This document is a response to the Jamaso (DA-2243-00) third submission comments received on March 22nd, 2022 by the Office of Development Assistance. Responses are below in **RED**:

Third Submission Review

RE: JAMASO – MASTER PLAN AND ZONING MAP AMENDMENT

Jamaso
Aurora, Colorado
Public Improvement Plan

Jamaso Public Improvements Plan Narrative City of Aurora, Colorado 02/24/2022

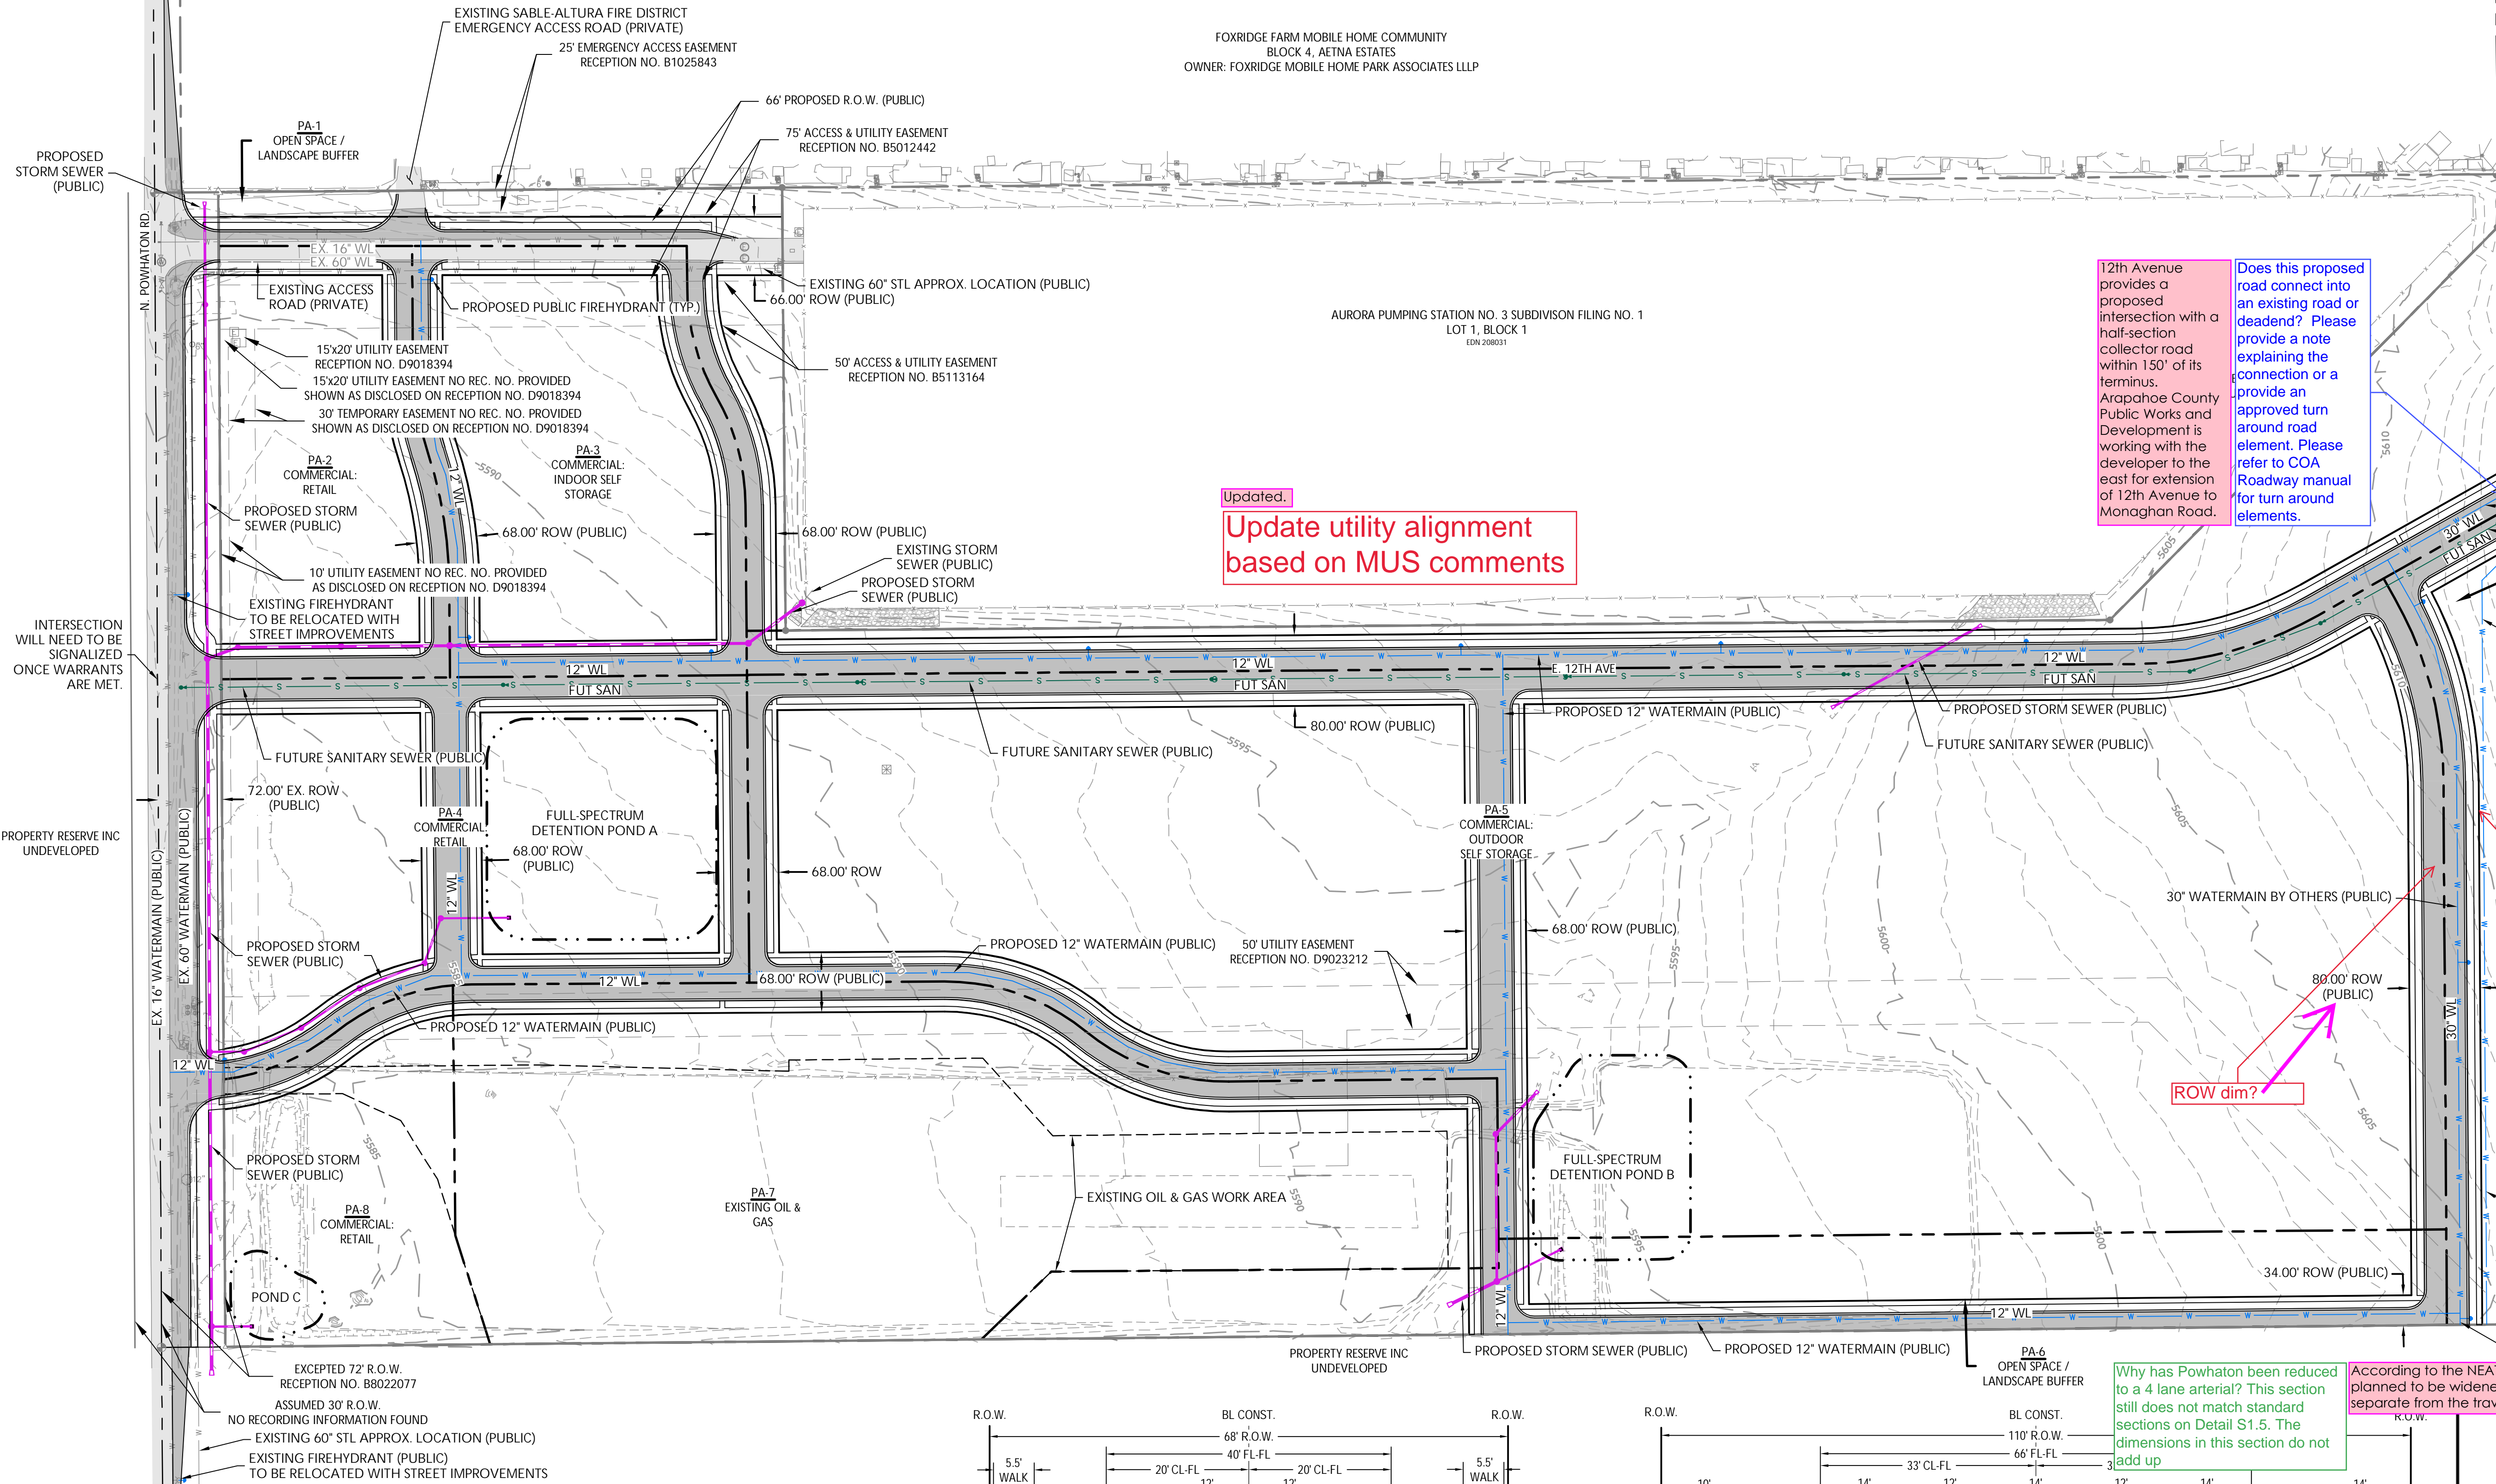
The master plan will not be approved by public works until the drainage study is ready to be approved. Comments were provided 9/27/21 and no subsequent submittal has been made

The drainage study is ready to be approved.

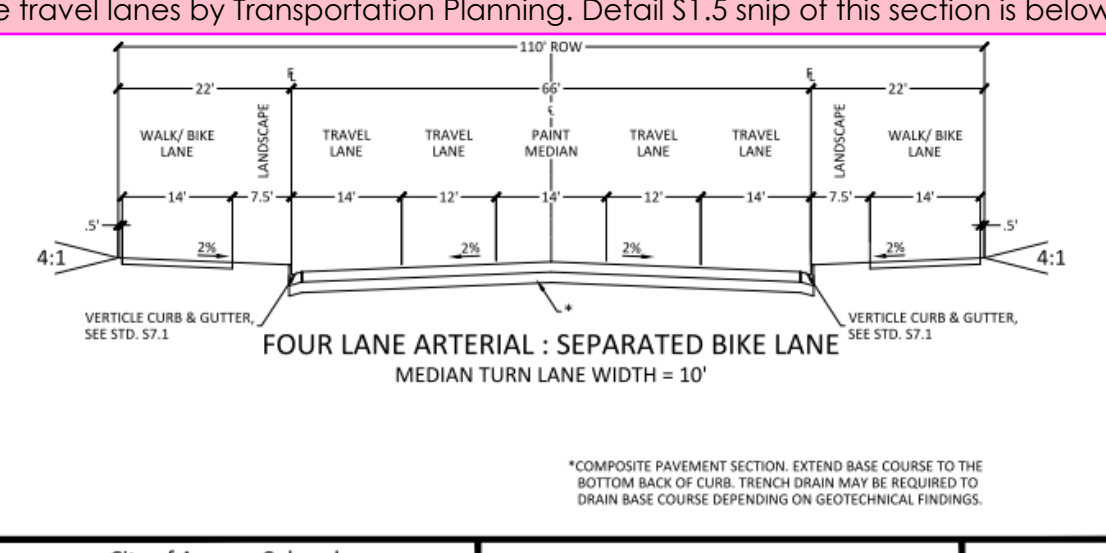
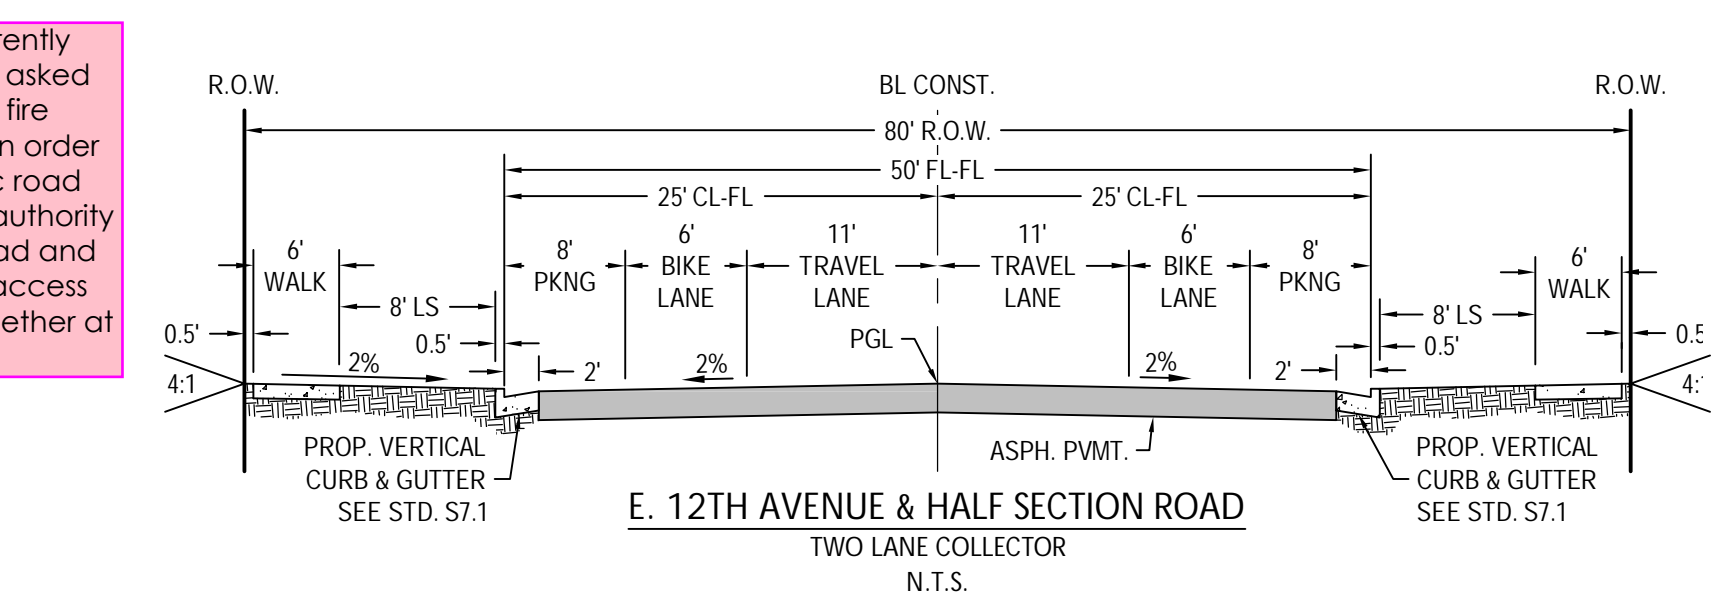
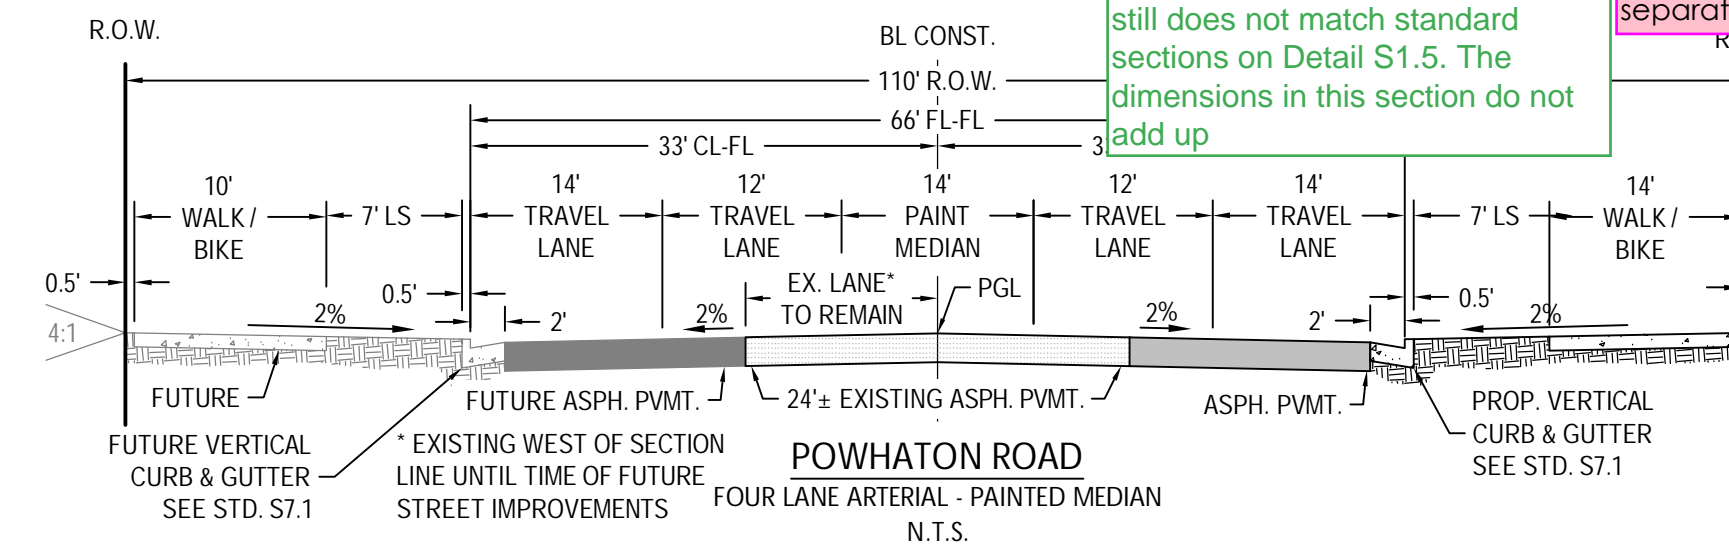
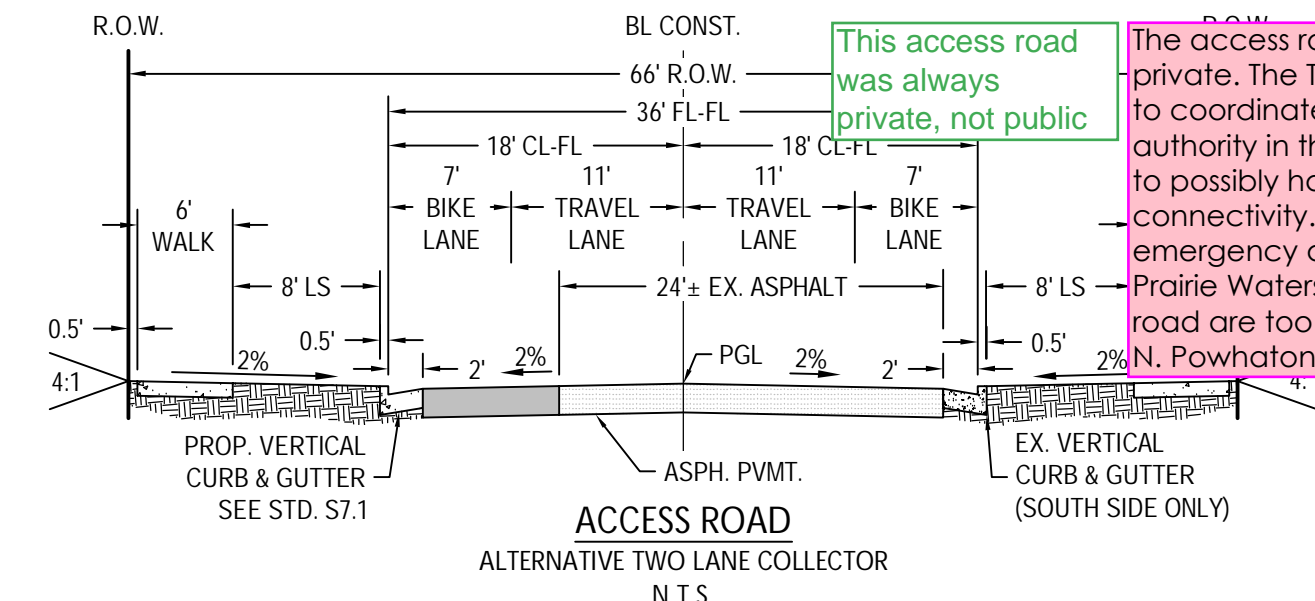
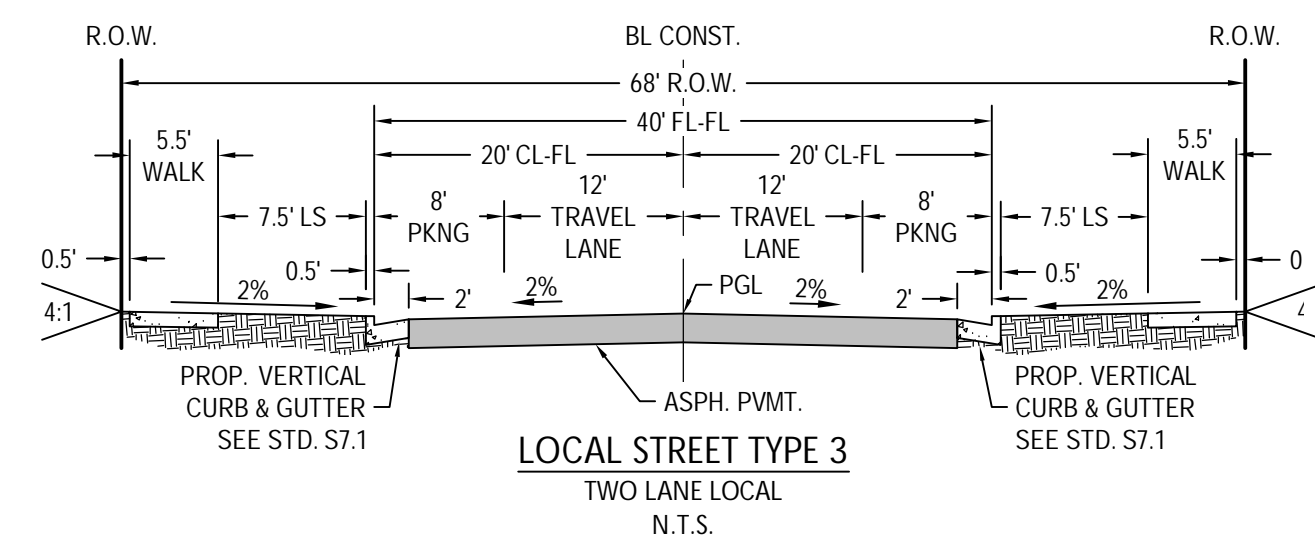
Does this proposed road connect into an existing road or deadend? Please provide a note explaining the connection or a provide an approved turn around road element. Please refer to COA Roadway manual for turn around elements.

ROW dim?

This waterline is to be within an easement in private property. PIP/MUS will not be approved until City has assurance that this easement can be acquired.

Why has Powhaton been reduced to a 4 lane arterial? This section still does not match standard sections on Detail S1.5. The dimensions in this section do not add up

12th Avenue provides a proposed intersection with a half-section collector road within 150' of its terminus. Arapahoe County Public Works and Development is working with the developer to the east for extension of 12th Avenue to Monaghan Road.

Provide adequate turnaround
Length from intersection is 150', therefore this ability to turn around is considered adequate.

According to the NEATS study, and discussed in the traffic study for Jamaso, N. Powhaton Road is planned to be widened to a four-lane major arterial by 2040. The bike lane was asked to be separate from the travel lanes by Transportation Planning. Detail S1.5 of this section is below.
